Commonwealth Edison Company

Preliminary Design Assessment
of the
Byron/Braidwood Generating Station Control Room
Human Factors Engineering Review
Supplement I

April 1983

Task Action Plan Item
I. D. 1. Control Room Design Reviews

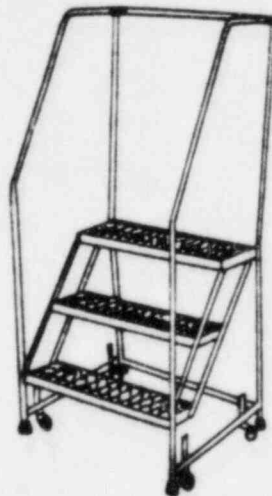
| 3 | 1.1 The design of the control room does not facilitate unobstructed movement and communication. For example, an operator seated at the center desk must traverse approximately 30 feet around the desk to reach a position that is only 10 feet away on a straight line. The design of the center desk may impair performance of the reactor operator/senior reactor operator stationed at the desk. (4.1.1) (2.1.1-1) |

CE Response: The present center desk has been replaced by a center desk system designed to facilitate operator movement and communication both within the center desk work area and with the operators located at each unit. The center desk has been arranged to minimize obstacles which influence operator mobility and permit the operators to perform their designated duties at the work station.

Figure A.

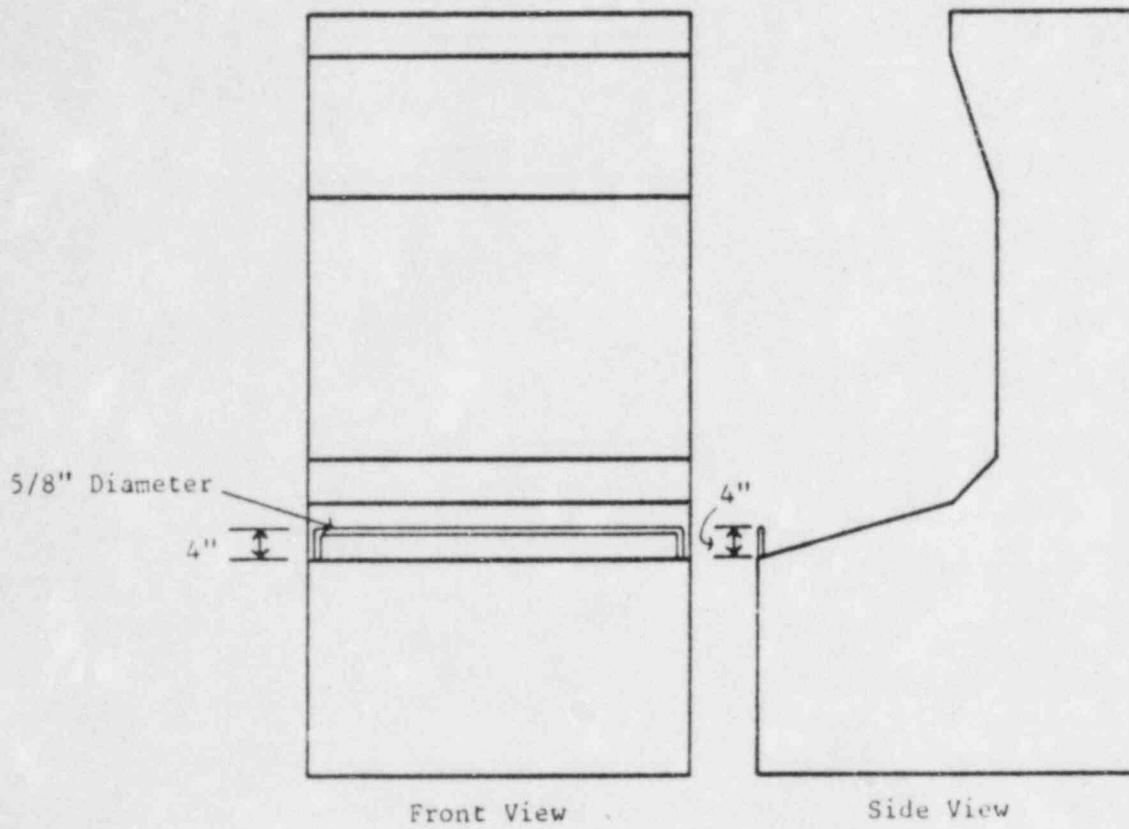
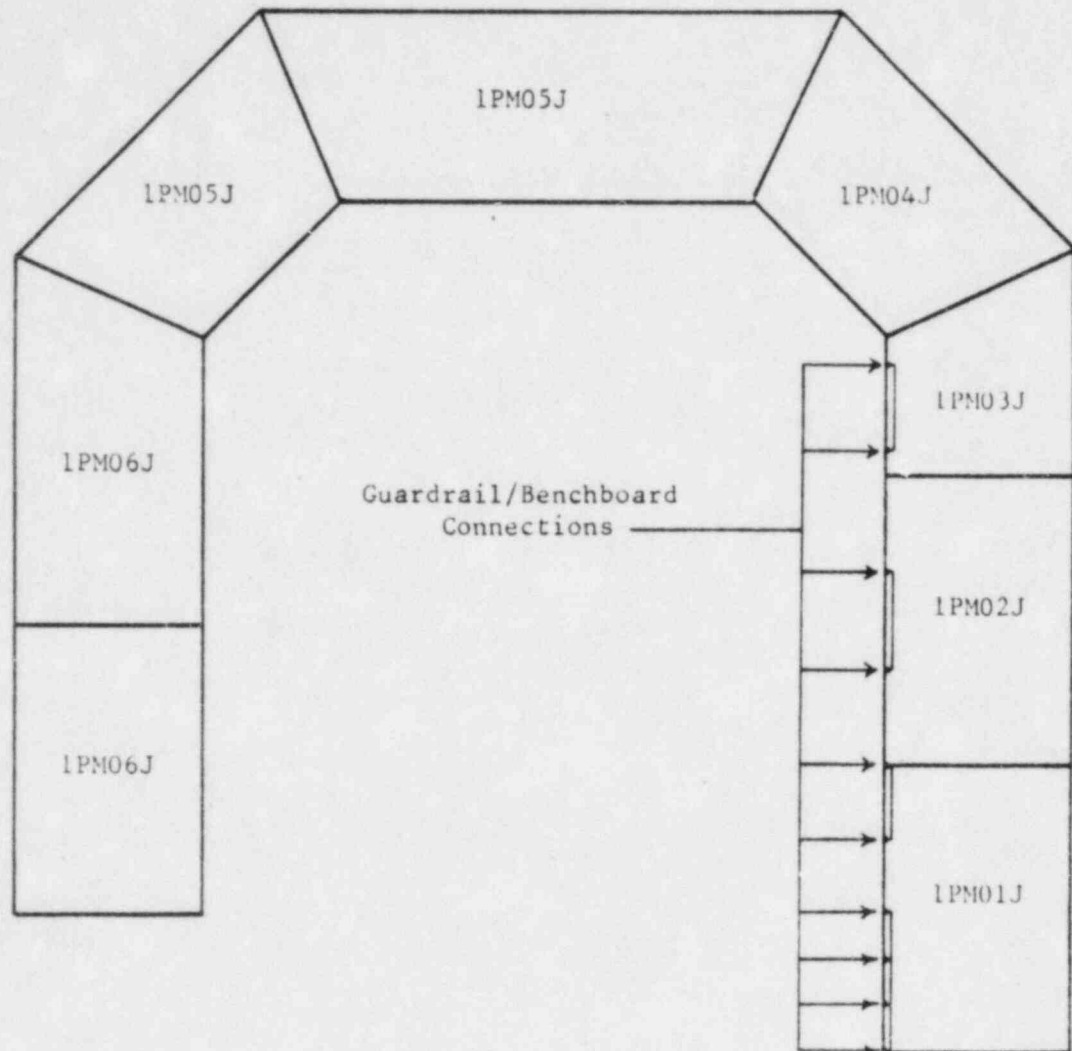
The J-Handle switches close to the edge of the benchboard section of 1PM02J, the Heater Drain and Turbine Control areas, and all switches on the common vertical panels (OPM01J, OPM02J and OPM03J) can be activated accidentally. (4.4.2) (2.2.1-2)

CE Response: J-Handle switches located close to the edge of the benchboard which could be inadvertently actuated have been inventoried. They are located on the 1PM01J, 1PM02J, and 1PM03J panels. To prevent an inadvertent actuation, a 5/8" round steel guardrail will be installed on these benchboards. These guardrails will be located 4" above the boards (Figure A) and will connect with the top of the benchboard at varying intervals (Figure B).

J-Handle switches on the vertical panels could also be inadvertently bumped by carts going through the passageway and people walking around the corners. A guardrail with the same specifications as above, will be placed 24" above the floor and 6" from the board across OPM01J, OPM02J, and OPM03J. Also, a guardrail will be placed vertically at the end of OPM03J to protect controls located near the side. This rail will be 23.4 inches long and located between 37.4 and 60.8 inches from the floor and 4 inches from the board.
